## ***Interactive comment on “Using global reanalysis data to quantify and correct airflow distortion bias in shipborne wind speed measurements” by Sebastian Landwehr et al.***

### **Response to Referee #1**

**Fig. 1.** Wind speed ratio as function of the relative wind direction. The marker colour denotes the absolute time difference to the 35 events, when data from UBXH3 was assimilated.

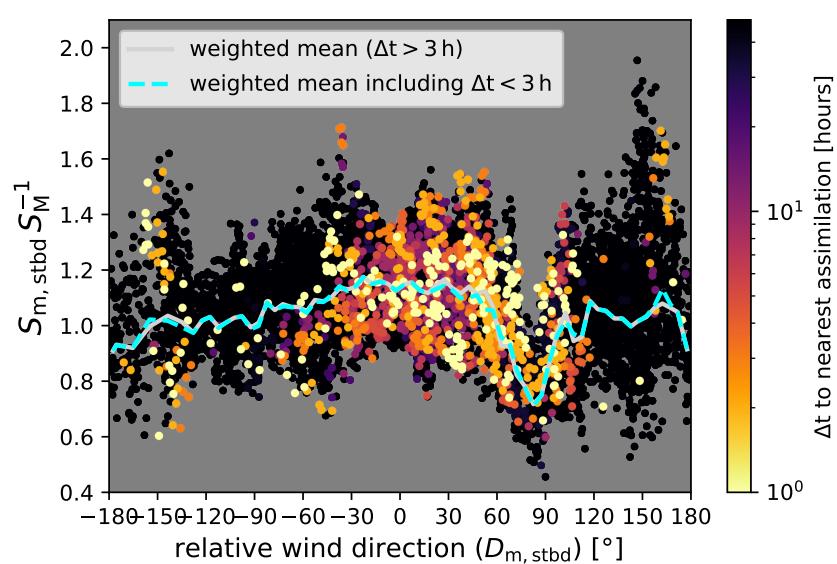
**RC 2:** *Introduction, 5th paragraph: The authors introduce reanalyses and note the assimilation of buoys and satellite data, but neglect the fact that ship data are also assimilated to most of these models. Were any data from the ACE cruise assimilated to ERA-5? I would expect if they were, they would have been from the standard hourly bridge reports that would be contributed to the Voluntary Observing Ship scheme.*

**AR 2:** Indeed wind speed observations from ships are still used in the data assimilation for ECMWF weather forecast model. In order to acknowledge this fact, we have added ships in the list of the in situ observations in page 3 line 3. The *Akademik Tryoshnikov* reported daily telegrams to the Arctic and Antarctic Research Institute (AARI). Following the request of the Scientific Committee on Antarctic Research (SCAR) and the World Meteorological Organisation (WMO), the observations were also reported to Global Telecommunication System (GTS) under the call sign UBXH3. ECMWF provided us with a list of the times and locations for which ground wind observations from UBXH3 were assimilated into the Integrated Forecast System (IFS) between November 2016 and April 2017 (see supplement information). The list contains 35 entries exclusively from leg 2, when the ship was south of 60°S. The data from intervals close to these time stamps cluster around ratio of  $S_m S_M^{-1} \approx 1$ , however, with considerable scatter (see Figure 1 that is attached to this reply). To avoid any feedback in the bias correction, we now excluded all observations that were within 3 hours before or after time stamps of the 35 assimilated observations. This leads to an additional removal of 1197 and 1216 five-minute samples for the port and starboard sensors, but has
